Planning Commission Report

Planning Commission Meeting: February 3, 2021		Agenda Item: 9-A
To:	Planning Commission	
From:	Jing Yeo, AICP, City Planning Division Manager	
Permit:	20ENT-0261	
Address:	2425 20 th Street	
Applicant:	Scott Myers, Empire Associates	
Appellant:	Thomas C. Malayil	
Subject	Appeal of the Architectural Review Board approval (20ARB-0204) of the design, colors, materials, and landscape plans for the construction of a new two-story, three-unit condominium development totaling 5,464 square feet with one subterranean level of parking.

Figure 5 – Rear (Alley) Elevation

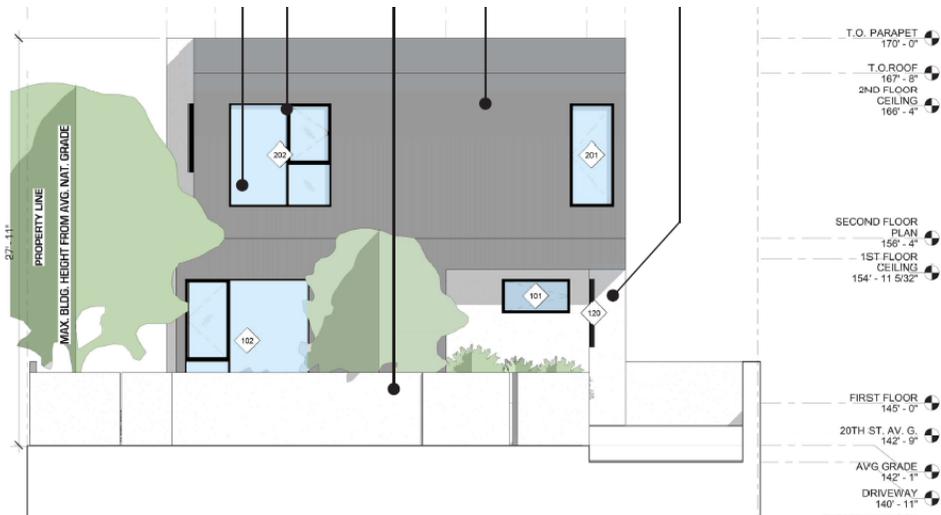
The appellant asserts that the ARB failed to consider the rear (alley) elevation as it is their opinion that there are design flaws due to large windows and lack of landscape screening.

While the rear elevation has windows incorporated into it, staff disagrees that this is a design flaw. As shown below in Figure 5, two windows have been provided at each story along the rear elevation to provide adequate light and air into the building. The ground floor windows will largely be screened by a combination of the 6' rear perimeter wall and rear landscaping. The second story windows will also be screened by rear landscaping and it should be noted that the top of the windows will be no more than 24' above average natural grade. However, additional landscape screening has been provided as described in the next paragraph to provide additional privacy for both the future property owners of the rear unit and the adjacent neighbors across the alley.

Figure 6 – Original and Revised Rear Landscape Plan (respectively)

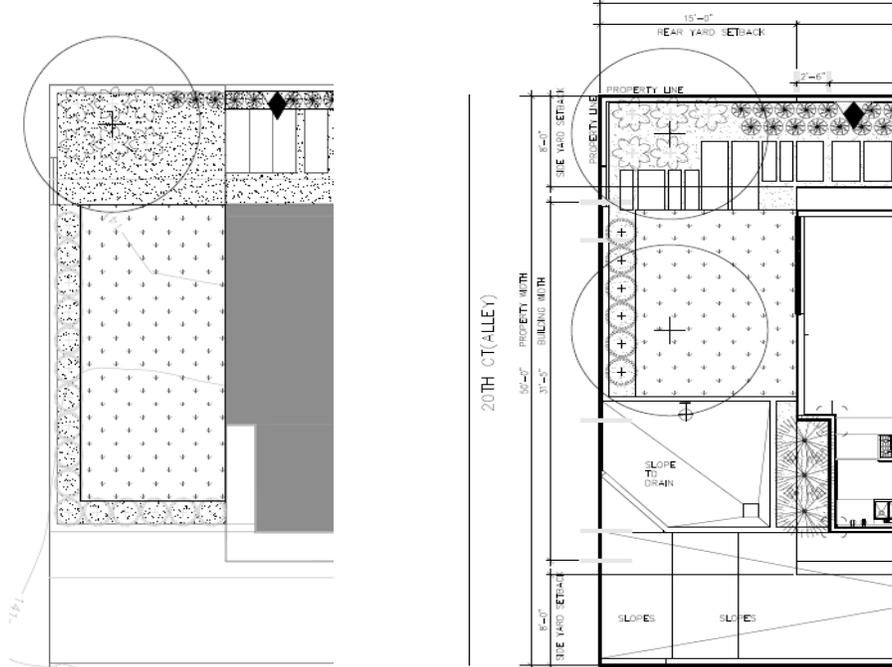
The appellant asserts that a compliant resource and recycling enclosure was not provided and that changes to accommodate an enclosure will require a revision to the rear landscape plan.

Pursuant to SMMC Section 9.08.030(D), when a multi-unit residential zone district is adjacent to an R1 District, transition requirements are required. In regards to landscaping screening the standard requires that a minimum 5' wide landscaped planting area be provided with trees planted at a minimum of 15' apart. As shown below in Figure 6, the proposed plans provided to the ARB and to the Planning Commission show a 15' landscaped area between the 6' high wall along the real parcel line and the proposed structure, except for areas needed for vehicular and resource/recycling access. An additional tree has been added to the rear landscaped area to provide additional screening to be in full Code compliance and to respond to expressed concerns.

The Landscape design has been revised for the rear yard due to the revised trash enclosure. This largely was comprised of a 126 SF reduction of open space and the removal of some vegetation. A comparison of the original and revised rear landscape plans can be seen above in Figure 6.

Figure 7 – Rear Portion of Site Plan

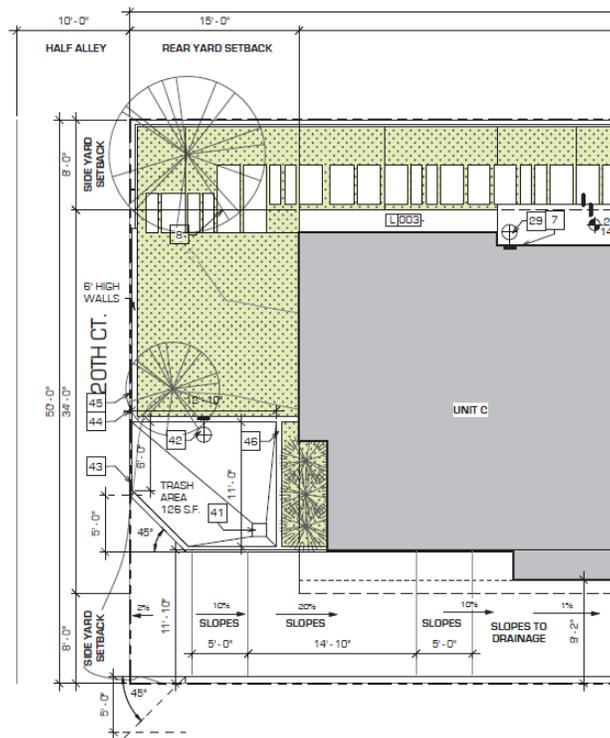
The appellant asserts that the alley vehicular access to the subterranean garage was not designed with proper safeguards for residents.

Pursuant to SMMC Section 9.21.180, Hazardous Visual Obstruction (HVO) triangles are required to be provided wherever a driveway intersects with a public right-of-way. HVO triangles are required in order to keep a clear line of sight at these intersections to ensure the safety of vehicular and pedestrian traffic. HVO triangles are required to be 5' x 5' with one leg located on the edge of the driveway and the other leg located on the property line, and are required to be kept clear of obstructions over 24" in height. As shown below in Figure 7, two HVO triangles have been provided where the driveway leading to the subterranean parking meets the alley. These safeguards were implemented in the plans reviewed by the ARB. However, to further ensure compliance, subsequent to the ARB meeting the applicant worked with the City's Mobility Division to review the proposed plans that have been provided to the Planning Commission and received approval on January 20, 2021. Therefore, staff is confident that adequate vehicular safeguards were and have been provided.
